29 February 2016

RE: Black River Wild Forest Unit Management Plan (UMP) Amendment

Figure 1a: Buffer Zone in BRWF

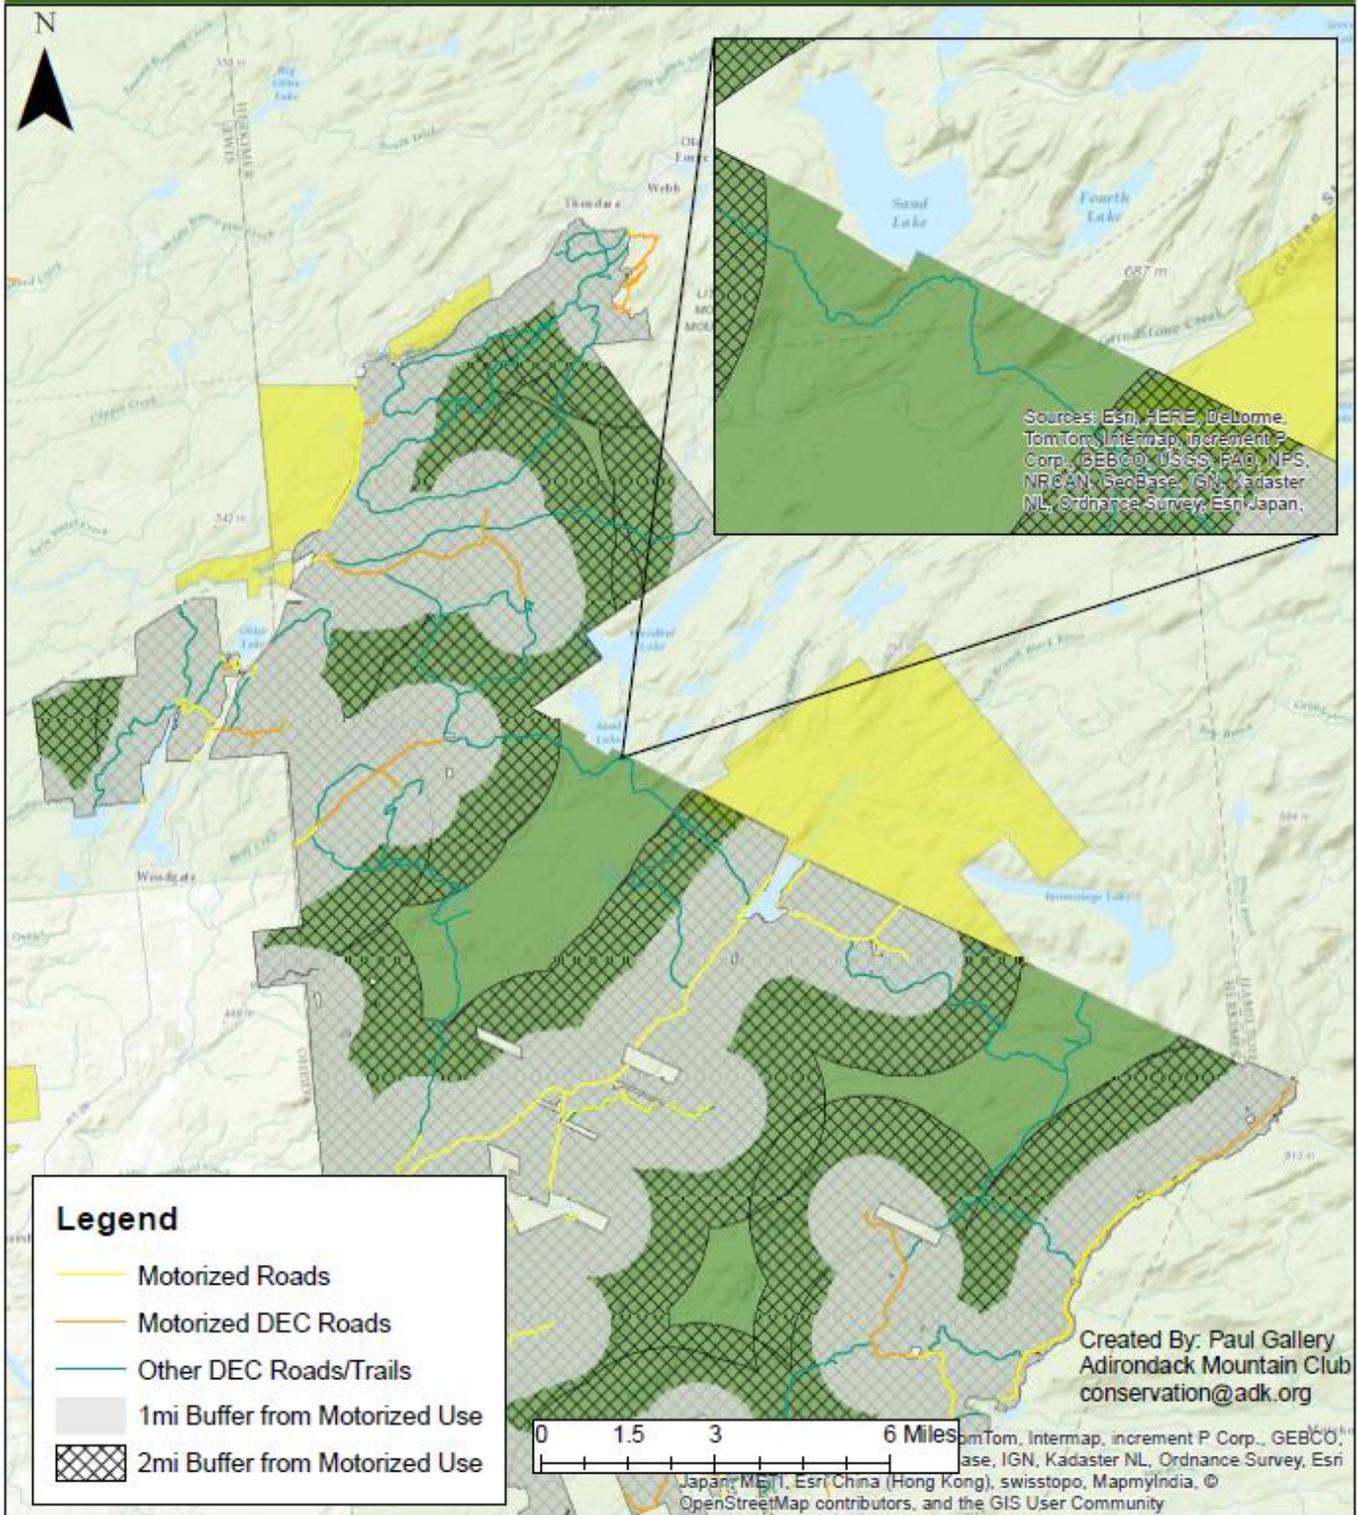
The first issue concerns Figure 1 in the amendment proposal. The map does not seem to follow the buffer rules correctly along the North Lake-Sand Lake-Mill

Creek (NSM) Trail. After creating our own map (see attached Figure 1a) using the same rules the DEC applied in Figure 1, we found there to be a noticeable difference in buffer location. Looking along the NSM Trail the 2 mile buffer area differs for both maps along this trail. We would greatly appreciate having DEC review and compare our attached map with Figure 1 in the amendment and help us understand the discrepancy.

According to our attached Figure 1a, the NSM would be a Class II “corridor trail” running through remote interior forest. In the 2009 Snowmobile Trail Siting Management Guidance, DEC describes Class II trails which “are located in the periphery of Wild Forest or other Forest Preserve areas” and “only rarely are any segments of them located further than one mile away from the nearest” motorized travel corridor. ADK therefore strongly oppose the proposal that the NSM Trail be reclassified as a Class II trail because it does not fit within the established guidelines for Class II trails.
